Dawn Mill and the Spokane Tribe

Alternative Concentration Limits (ACL)

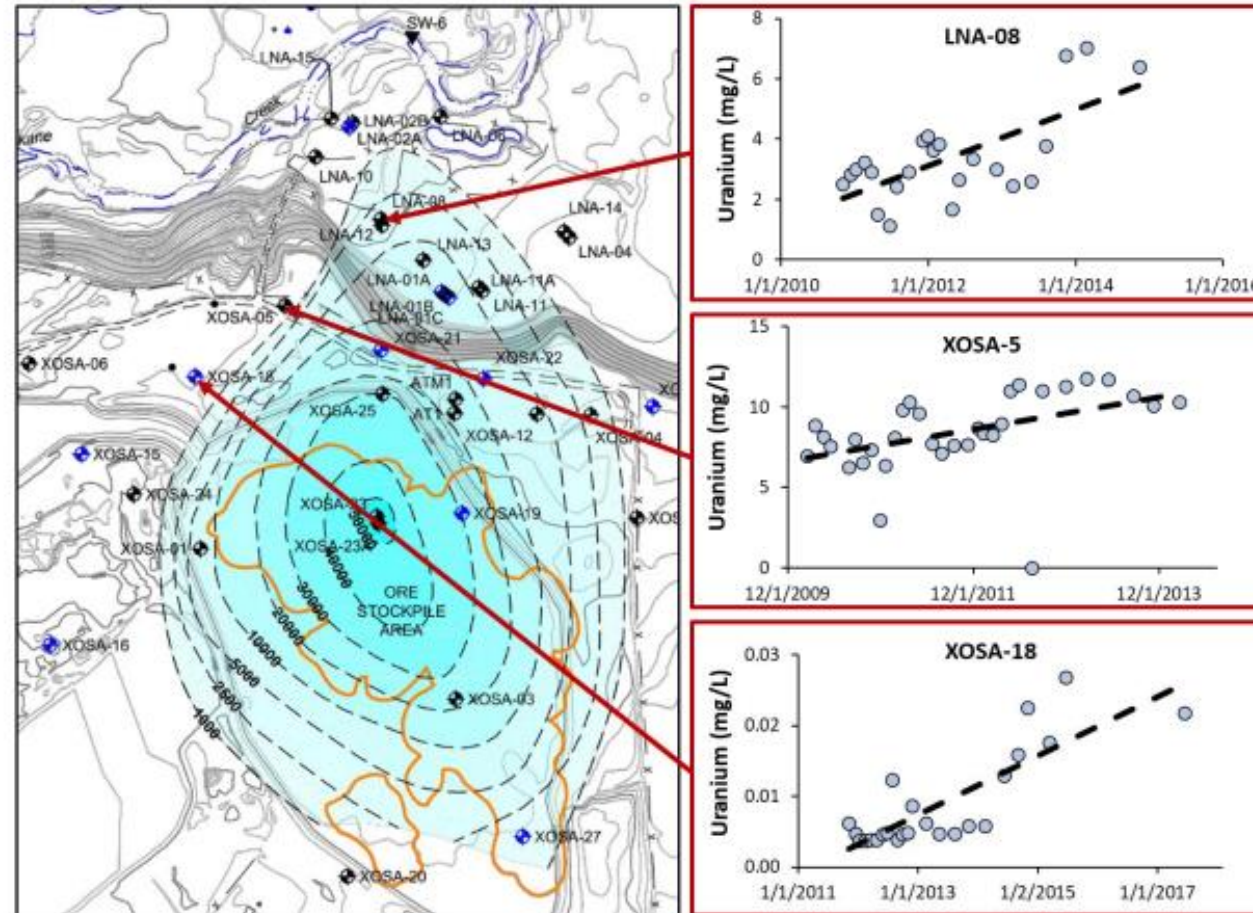
Figure 3. Site data show that concentrations of uranium are increasing in multiple wells (LNA-08, XOSA-5, and XOSA-18) in the northern plume area. In addition, concentrations at several upgradient wells (located toward the center of the plume) have remained constant over the past decade (e.g., XOSA-21, XOSA-23, XOSA-25), contrary to modeled results presented in the ACL that show declining trends.

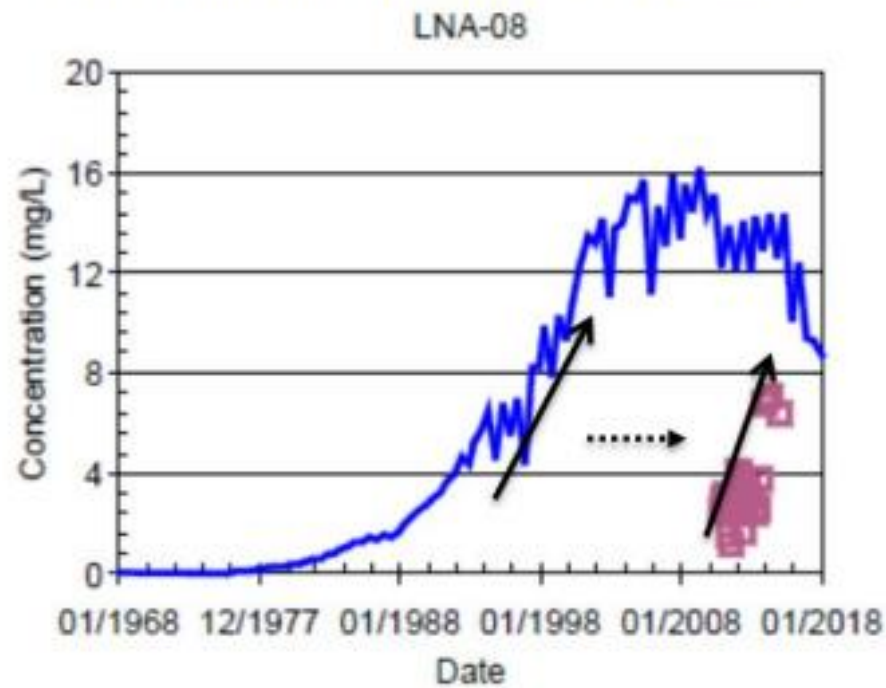
Figure 3. Model output for well LNA-08 (blue line) compared to measured samples (maroon squares). Black arrows have been added to show that the measured increases in uranium concentrations between 2008 and 2016 follow a similar trend predicted by the model ~ 15 years earlier. The original figure is from Figure 5-8 in Appendix A of the ACL Application.
